RESPONSE TO COMMENTS ON THE PRELIMINARY CONTAMINATION ASSESSMENT
REPORT CONTAMINATION ASSESSMENT PLAN FOR CHICORA TANK FARM CNC
CHARLESTON SC
07/17/1992
KEMRON ENVIRONMENTAL SERVICES, INC

Project 819-300

RE: Chicora Tank Farm
Charleston Naval Shipyard
GWPD Site #A-10-AA-13350

Figure 1. French drain manhole schematic with vertical exaggeration

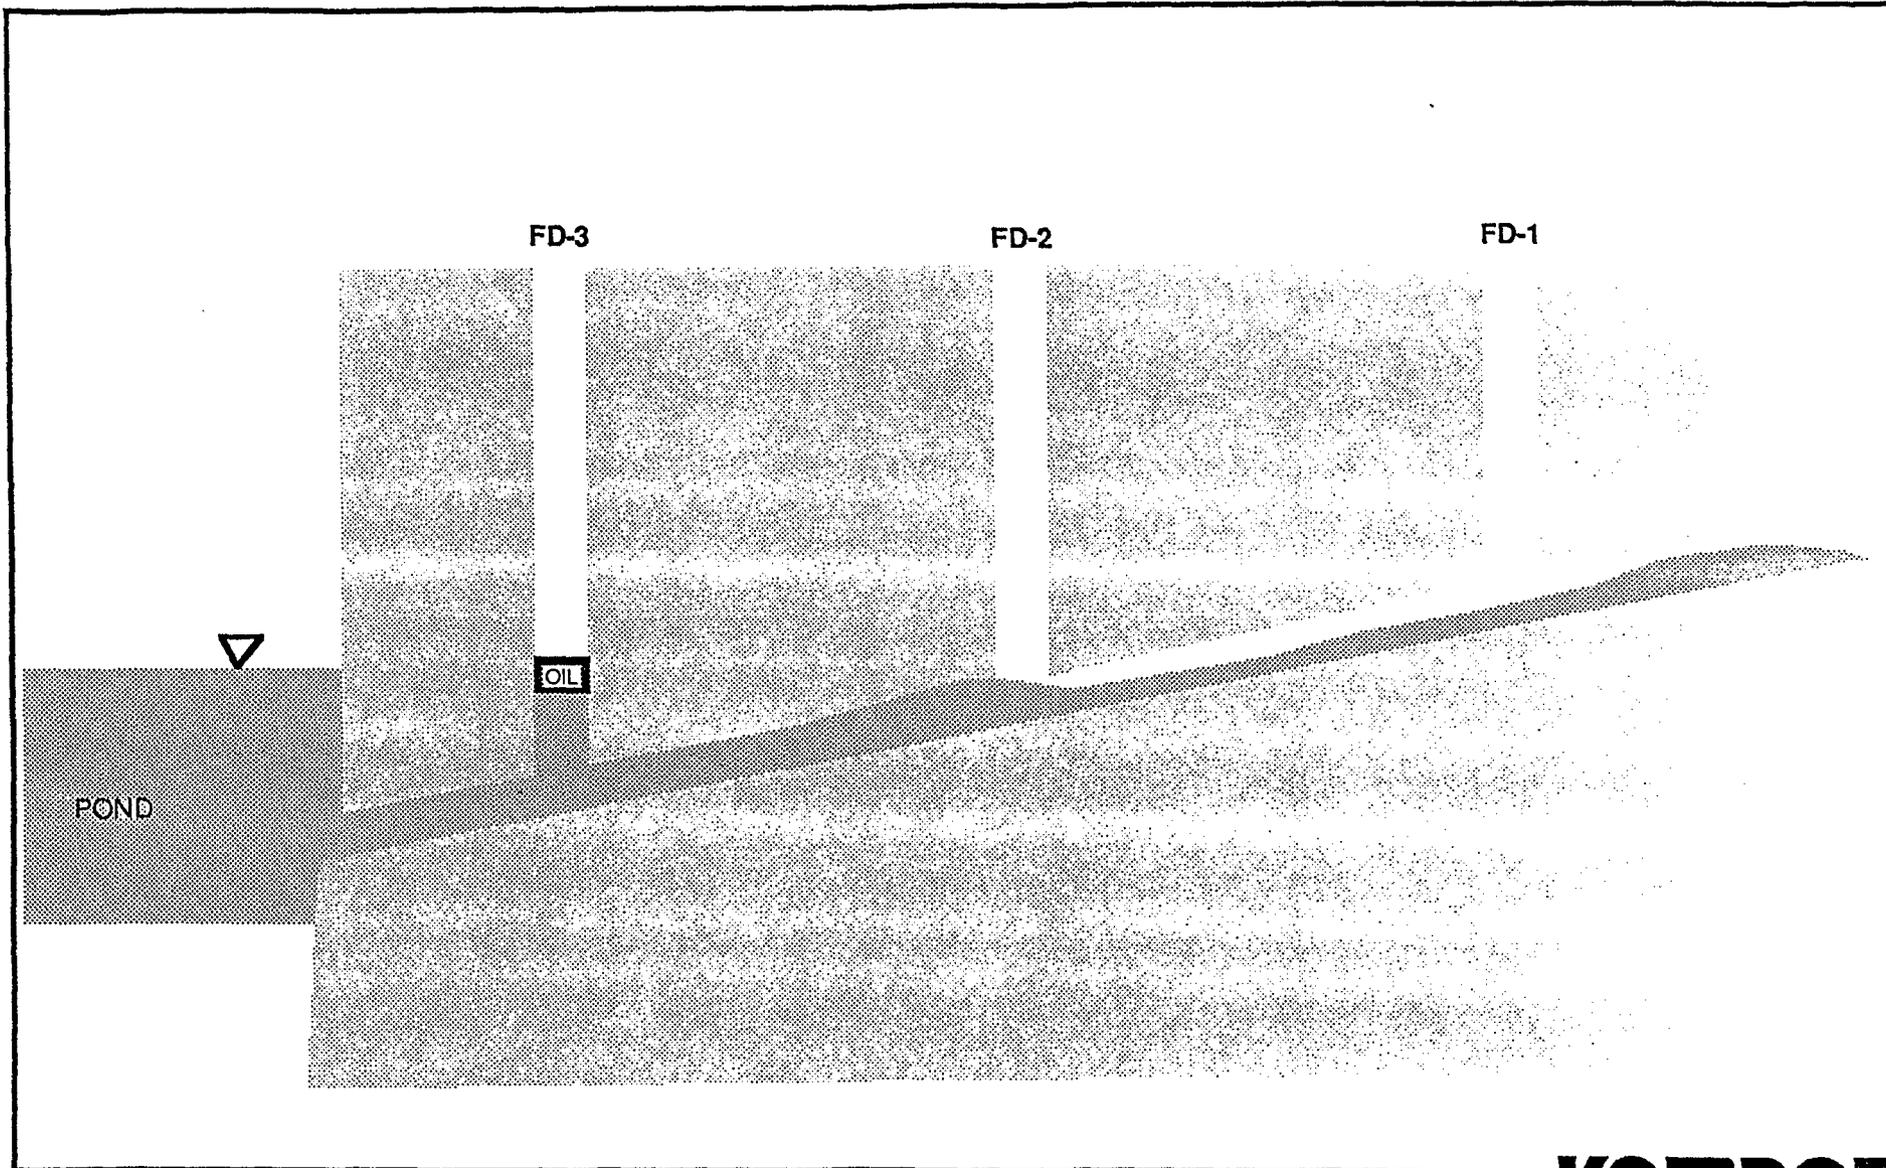
2. Free-product removal (§3.1.2.2) is planned for french drain manhole FD-3 only. Free product has not been observed in FD-1; only a sheen was observed in FD-2. Oil only accumulates in FD-3; it does so because it functions, in some ways, like an oil/water separator. See attached figure. Consequently, no changes have been made to this section.
